RS-09-113

LaSalle County Station, Units 1 and 2
Facility Operating License Nos. NPF-11 and NPF-18
NRC Docket Nos. 50-373 and 50-374

Subject: Response to Request for Additional Information Regarding Relief Request CR-26

COMPONENT ID RH-HX1B-1

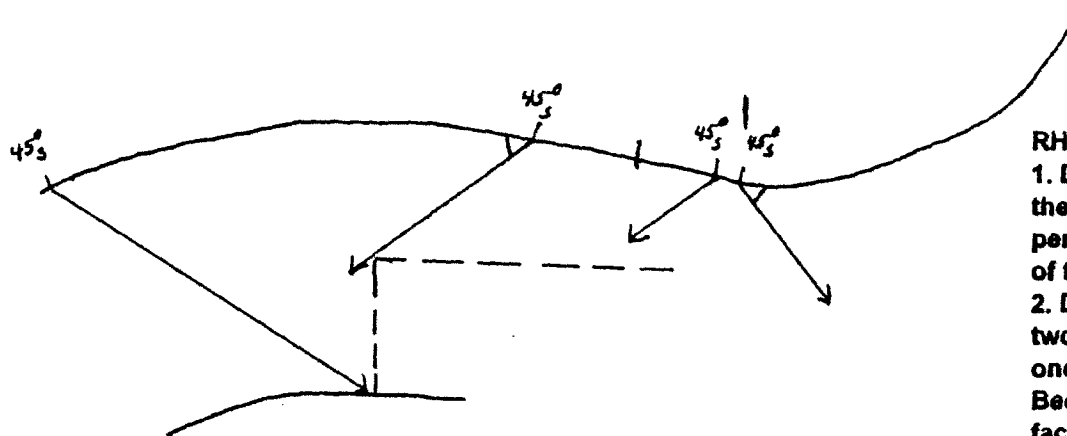
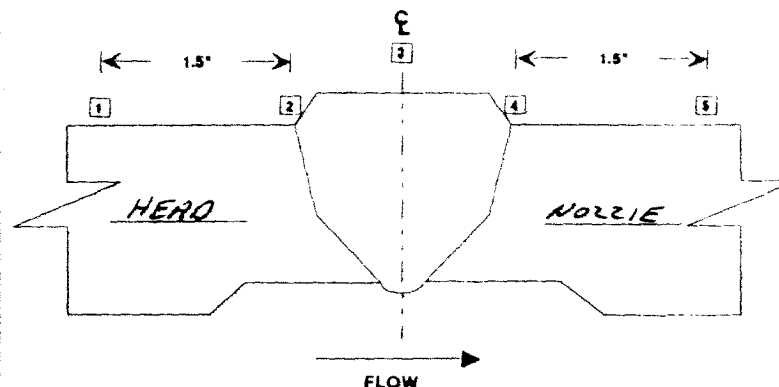
Provide further information to adequately demonstrate the impracticality associated with Weld RH-HX1B-1 on Residual Heat Removal Heat Exchanger 1B. Include sketches or drawings as necessary, to show coverage obtained and describe the materials and the ultrasonic techniques applied.

1. Due to the configuration of the nozzle, no axial exams were performed on the base material of the nozzle.

2. Due to the cladding on the ID two direction coverage from one side is not possible. Because of these two limiting factors, 80% coverage of the code required volume was achieved.
